CLONBURRIS T2

ARCHITECTS
FURTHER INFORMATION
RESPONSE

Planning Reg Ref: SDZ22A/0018

July 2023

Item no. 1 (b)

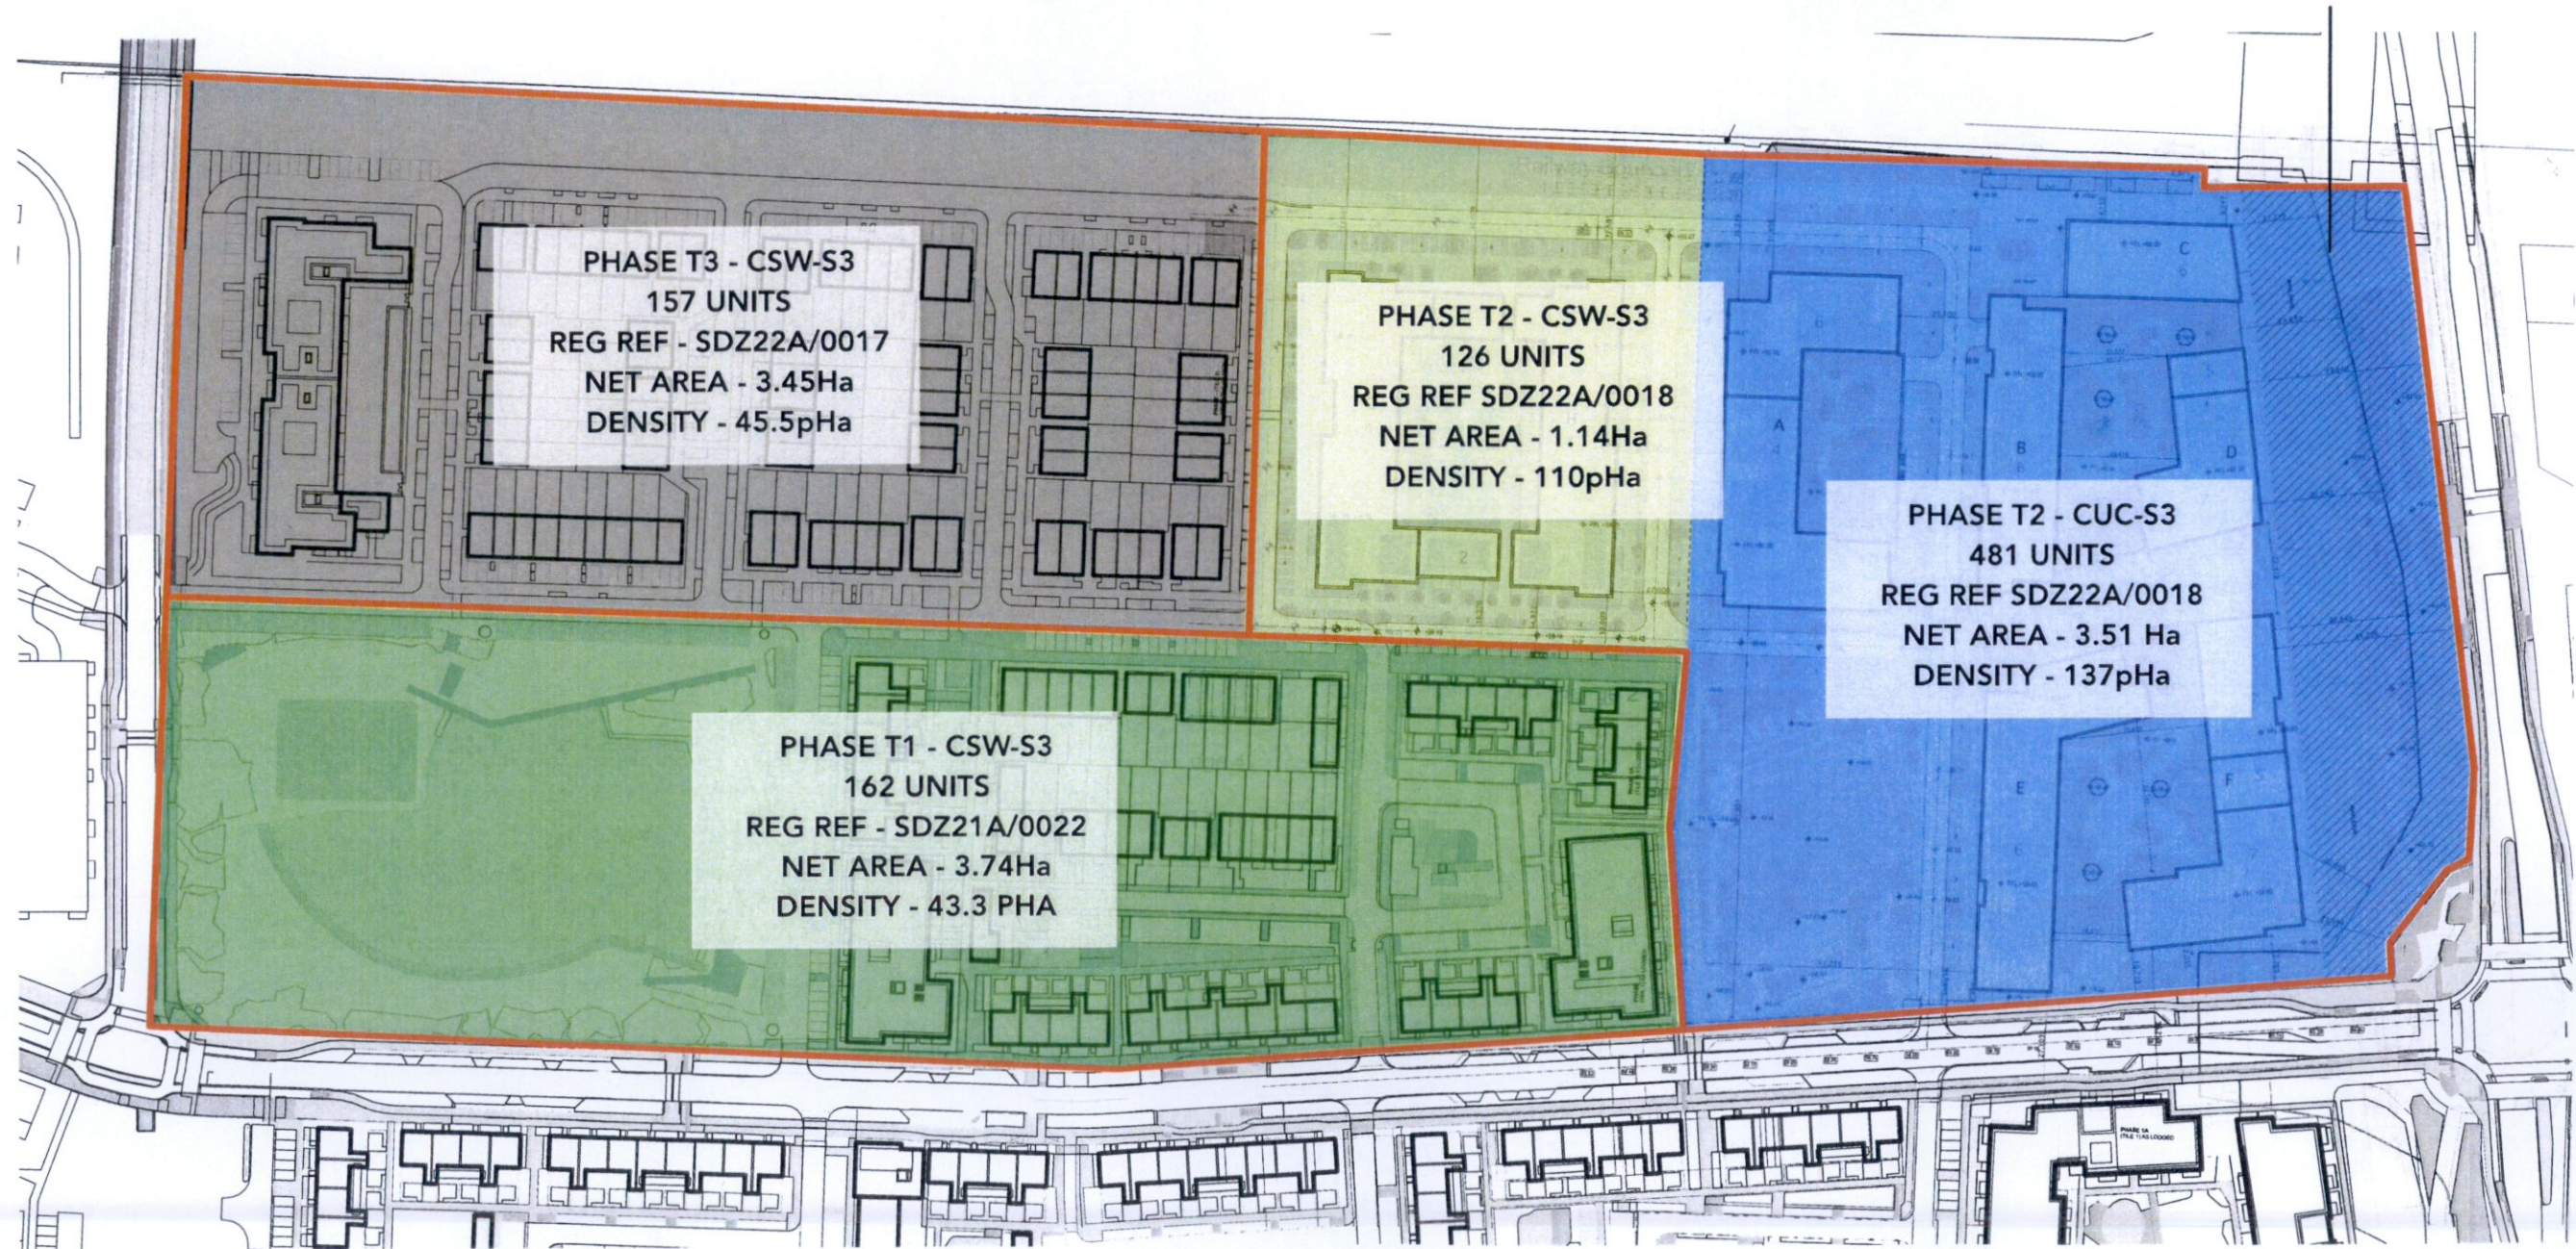
b. The applicant is requested to set out the net development area for CUC-S3 and the net development area for CSW-S3. The applicant is requested to detail how the total net development area for CSW-S3 is met through applications SDZ21A/0022, SDZ22A/0017 and SDZ22A/0018.

CSW-S3		CUC-S3	
T3	445 UNITS		481 UNITS
T2	NET AREA - 8.33Ha	T2	NET AREA - 3.51Ha
T1	DENSITY - 53,4pHa		DENSITY - 137pHa

EXCLUDING WAYLEAVE AREA
 Gross Area: 3,84 ha
 Net Area: 3,51 ha

Item no. 1 (c)

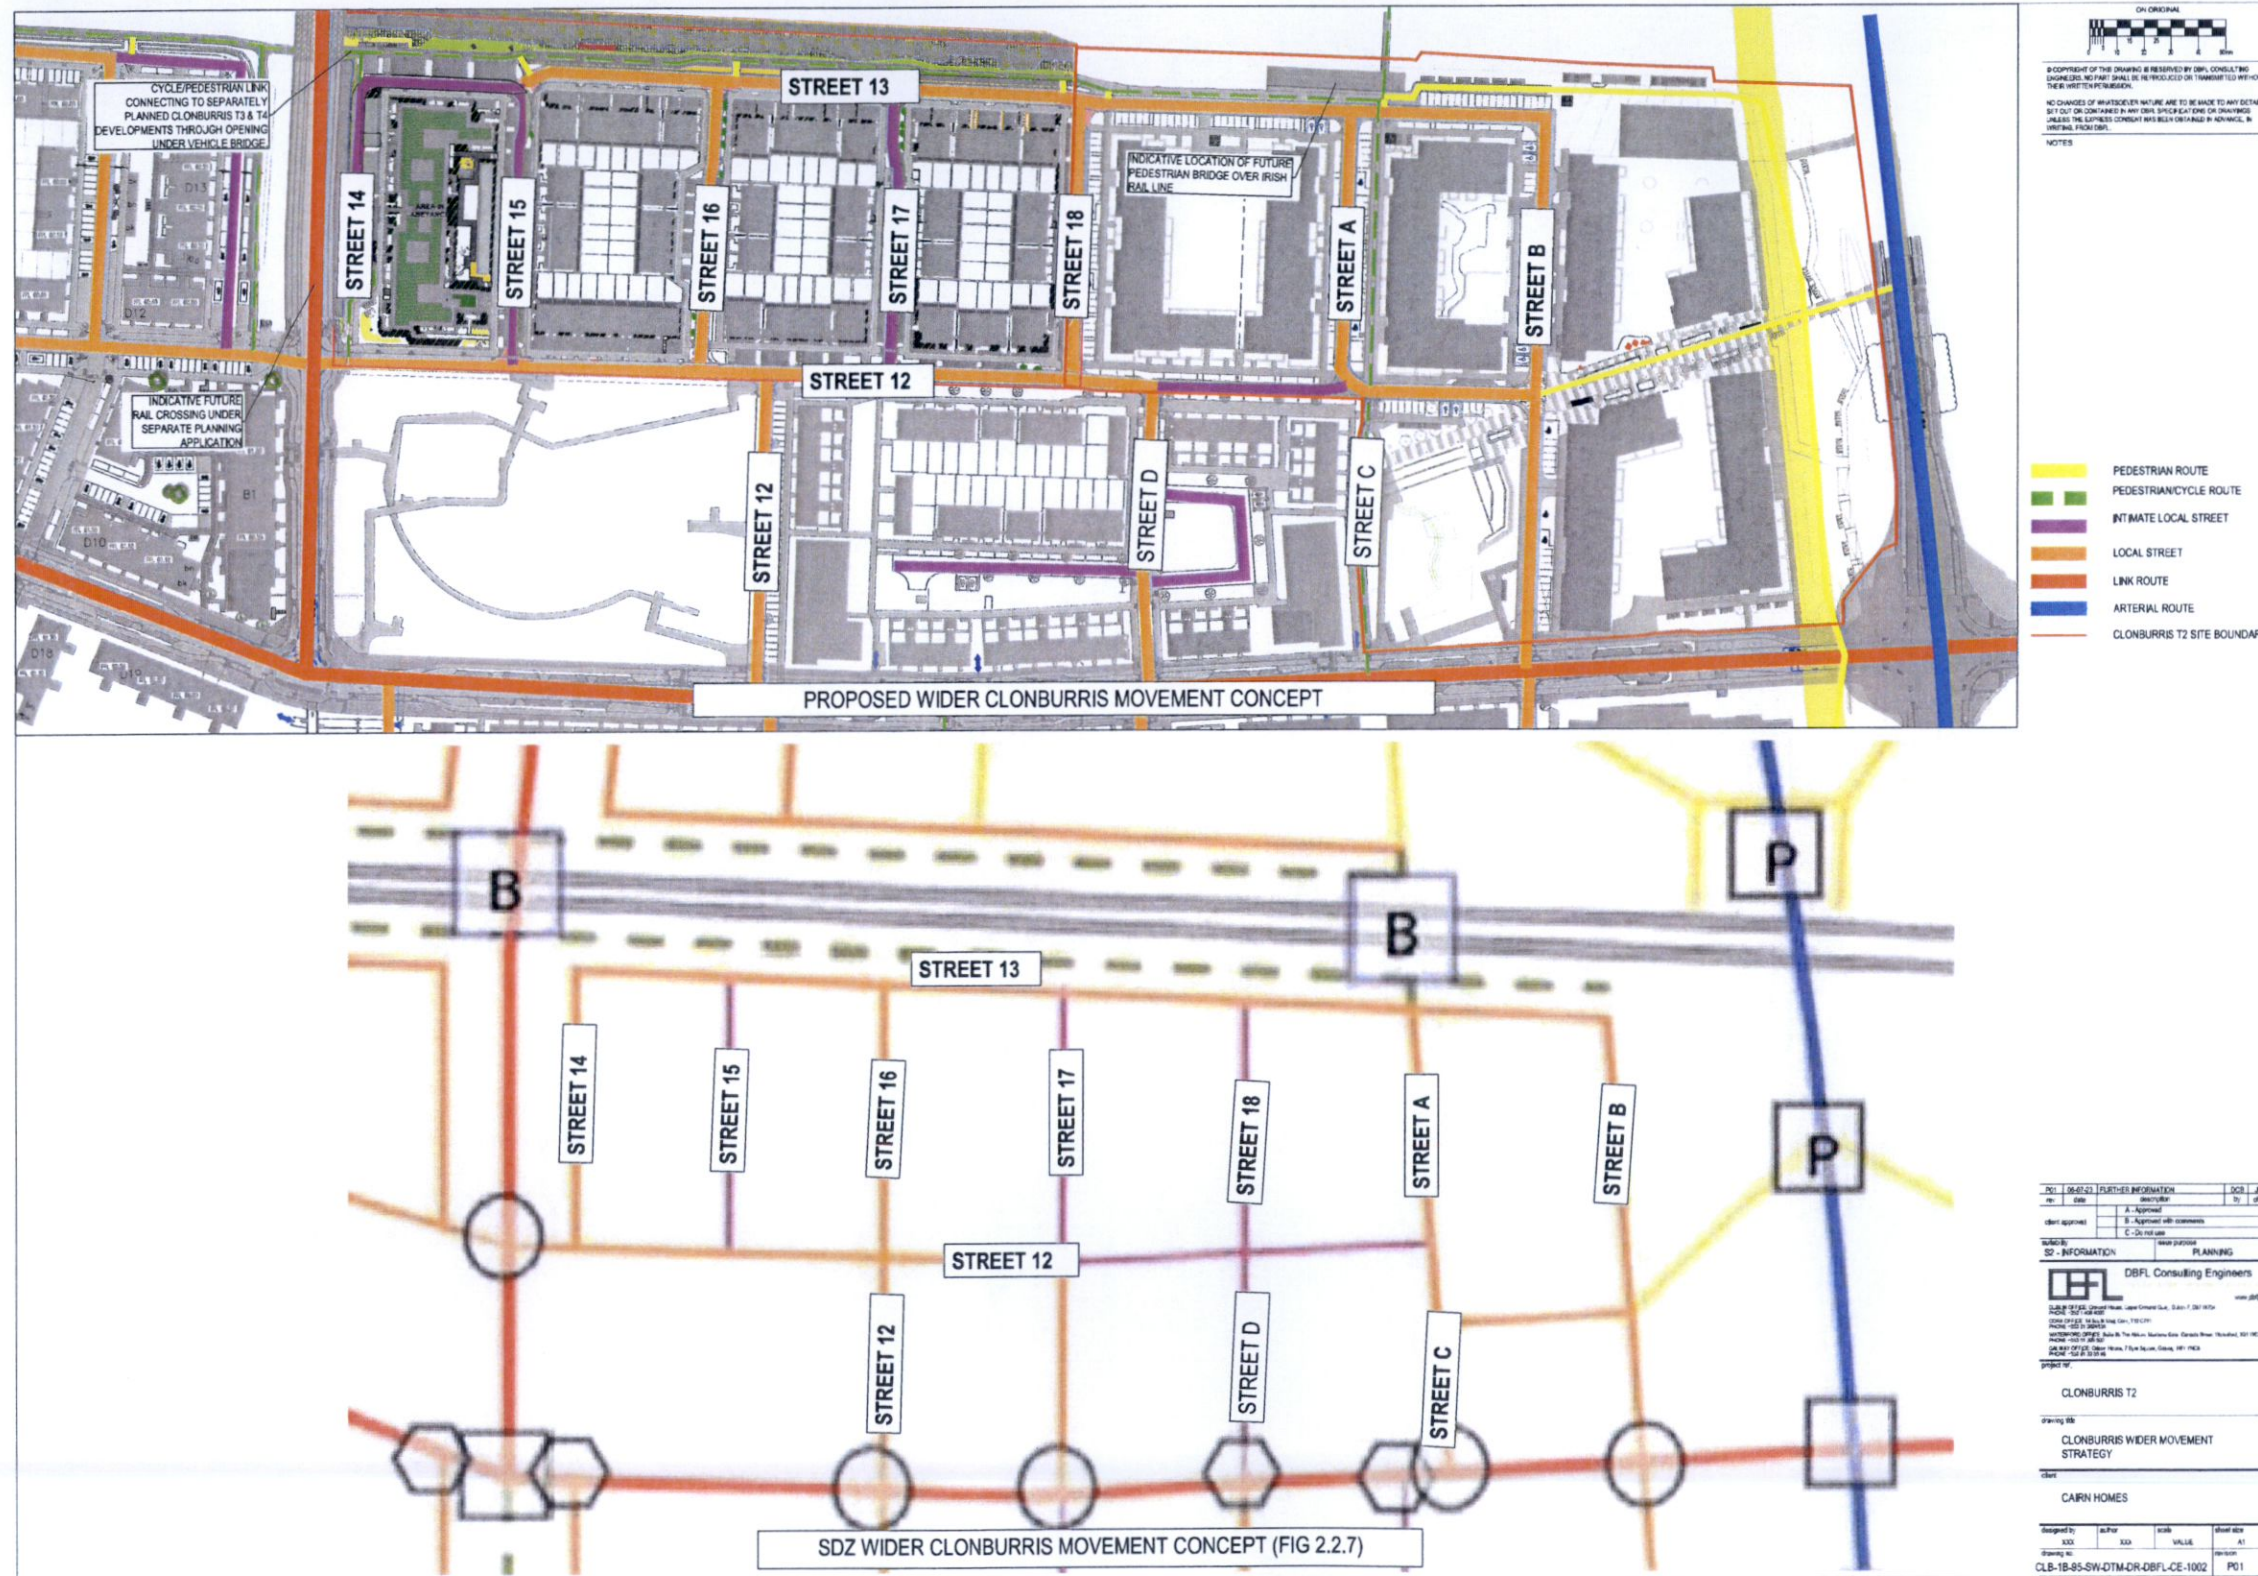
The applicant is requested to demonstrate that the strategic pedestrian / cycle route to the north of the site, along the railway, links to the cycle track proposed on the adjacent sites.

Please refer to DBFL Consulting Engineers FI Report
